STEFFEN ROBERTSON AND KIRSTEN (B.C.) INC. Consulting Engineers
Suite 800, 580 Hornby Street, Vancouver, B.C. Canada V6C 3B6
Phone: (604) 681-4196 Fax: (604) 687-5532

June 27, 1990

Project Number 60619

RE: Room and Pillar Review

FIGURE 3

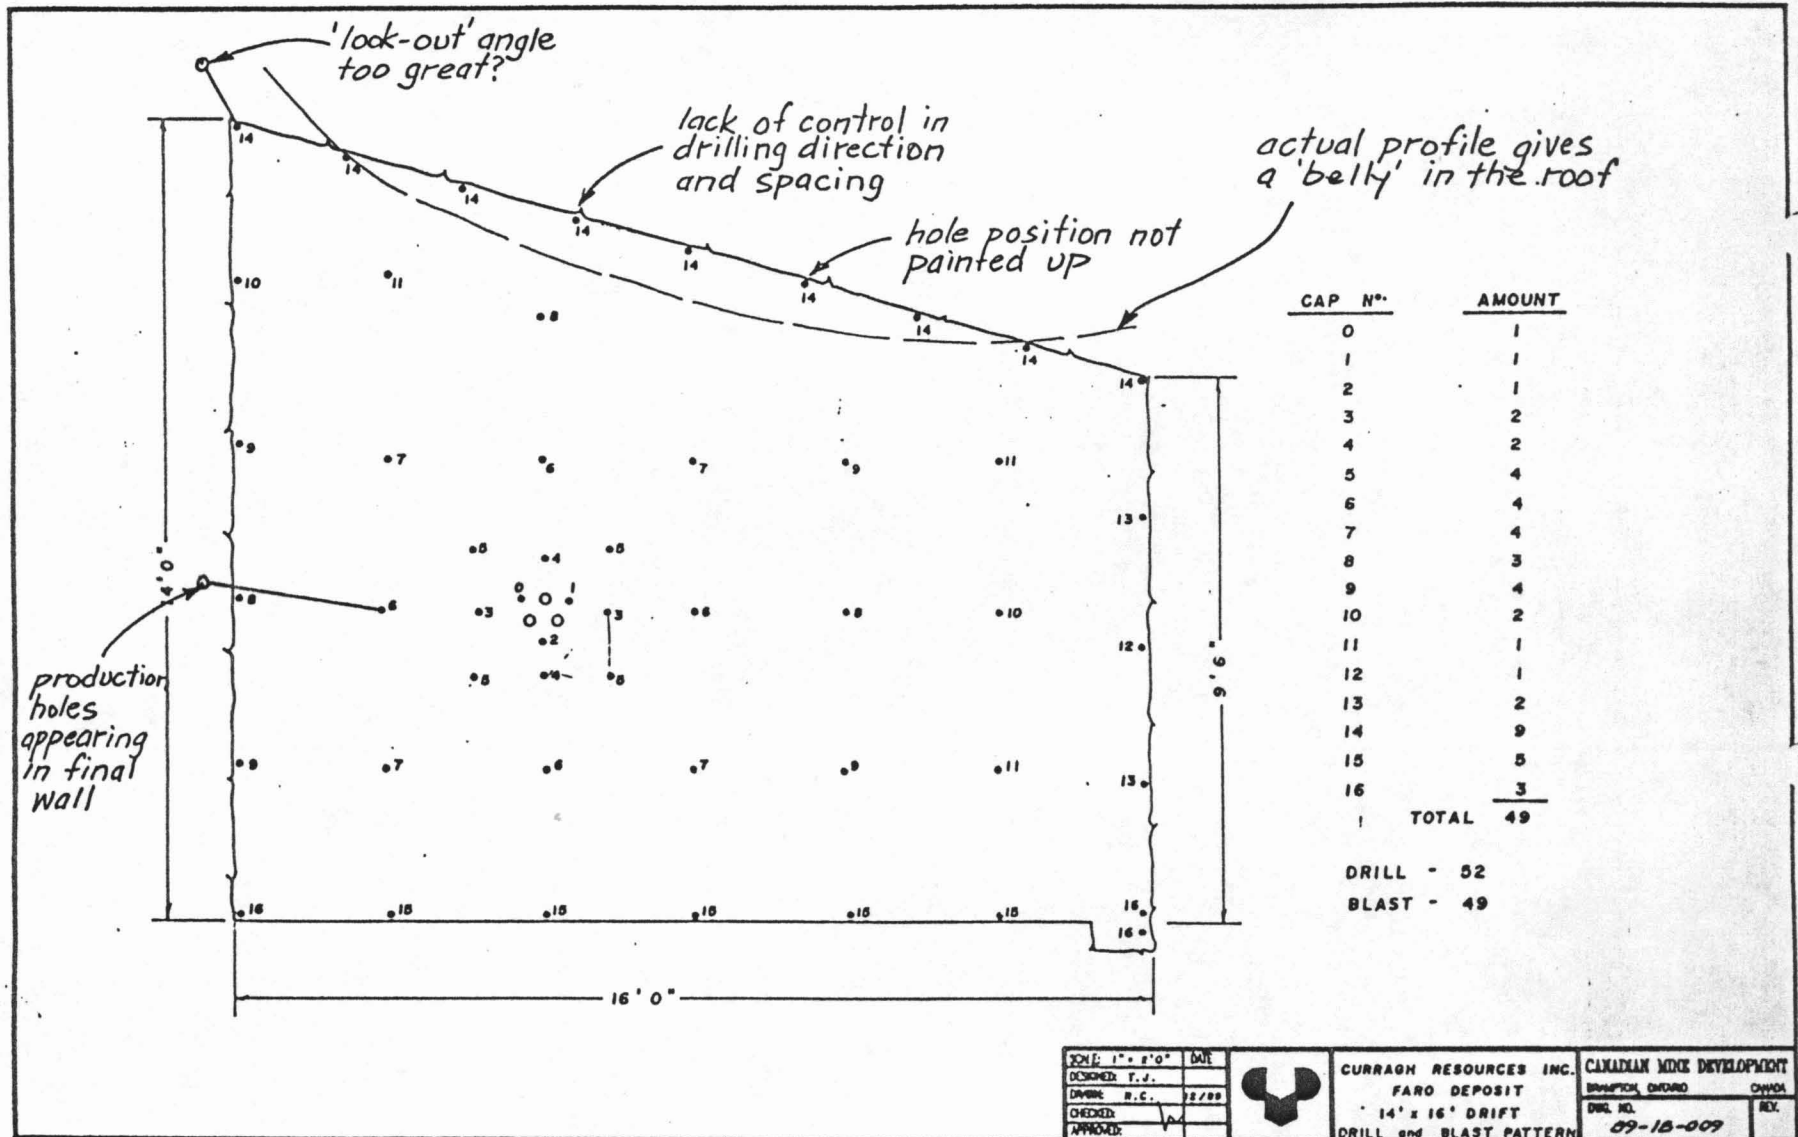
It is evident that there is no auto-parallelism on the drill jumbos, or it is not in use, and that there are many instances of incorrect hole alignment. This problem is especially critical in the corner holes of the roof. These are consistently overbreaking due to large look-out angles. The roof often has a convex profile due to poor spotting of holes and differences in hole angle. These points are highlighted in the accompanying sketch, Figure 3. It does not appear that the hole pattern is formally marked-up at the face. The angle on the holes varies throughout the round. The result of poor layout is an uneven roof and walls, extra confinement for some of the holes and overbreak. The resulting surfaces will, therefore, be less stable.

FIGURE 4

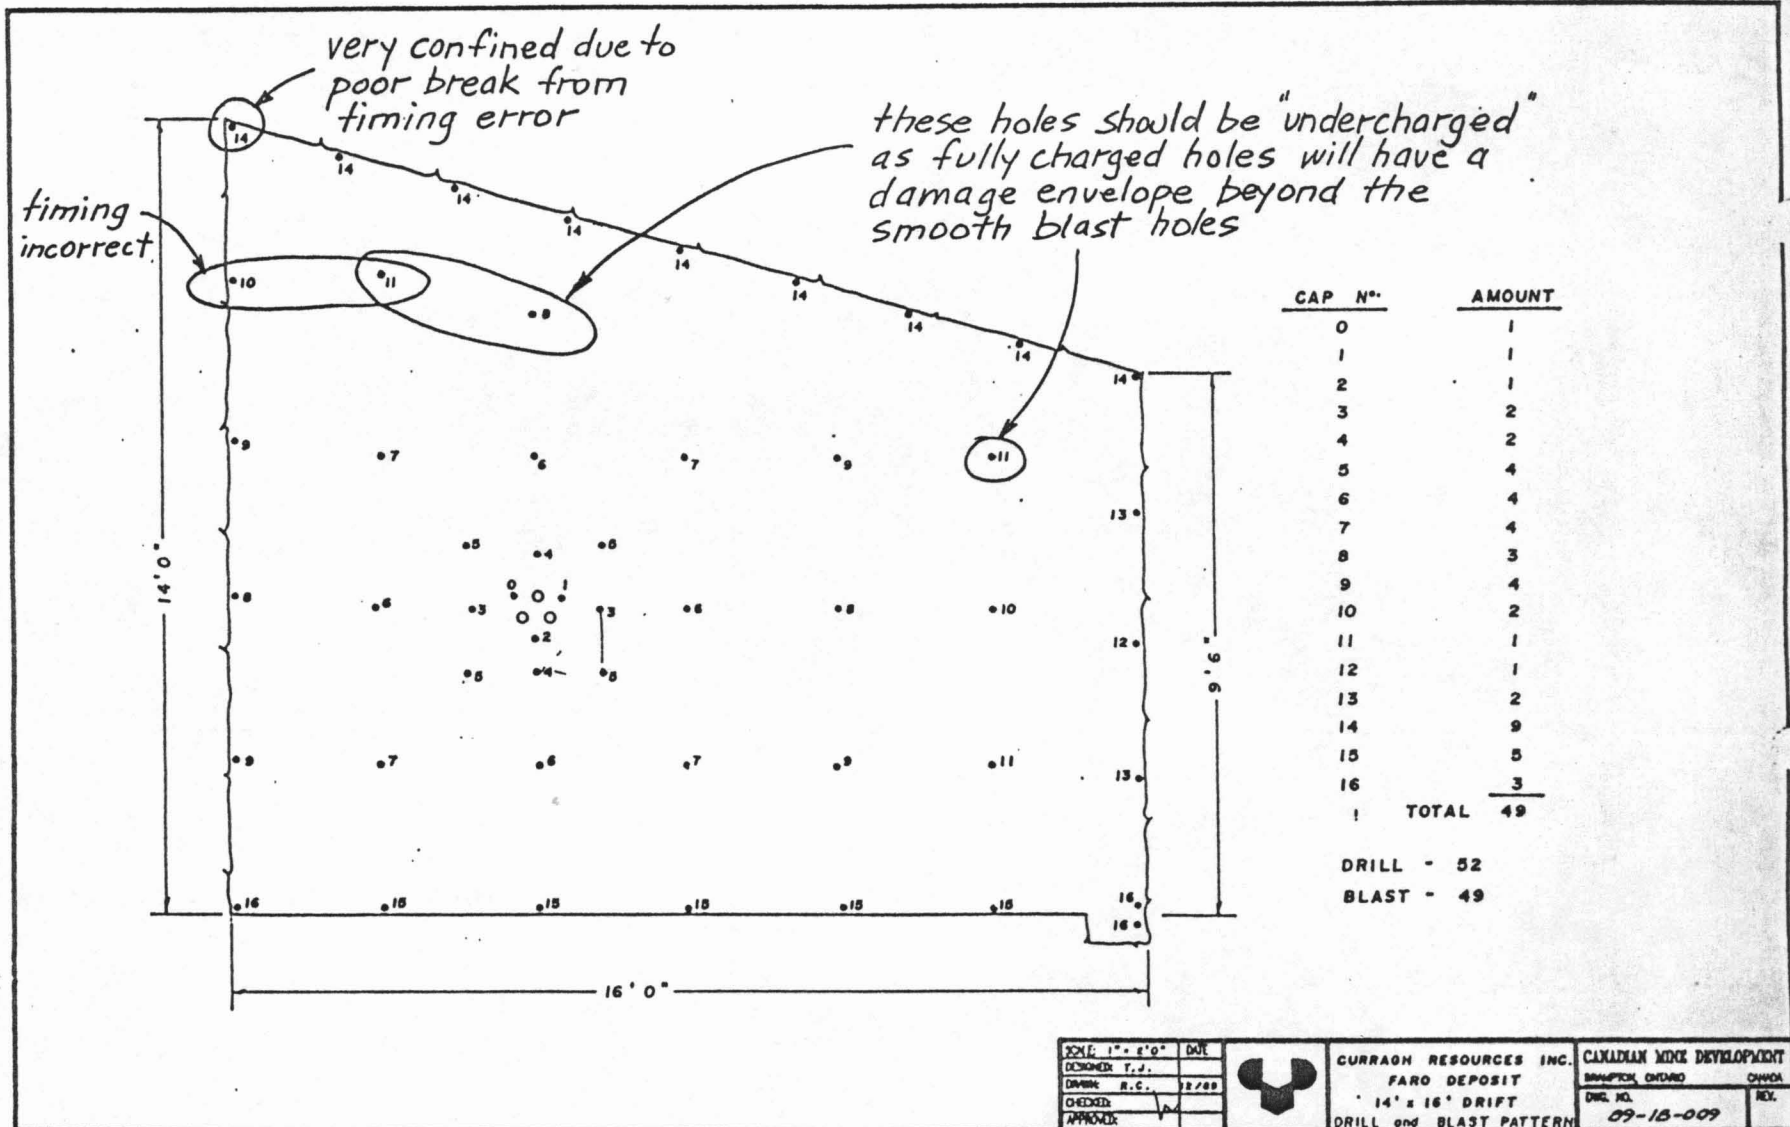
A review of the standard drill layout indicates two problem areas. These are identified in Figure 4 and concern incorrect timing and overcharging of holes close to the roof.
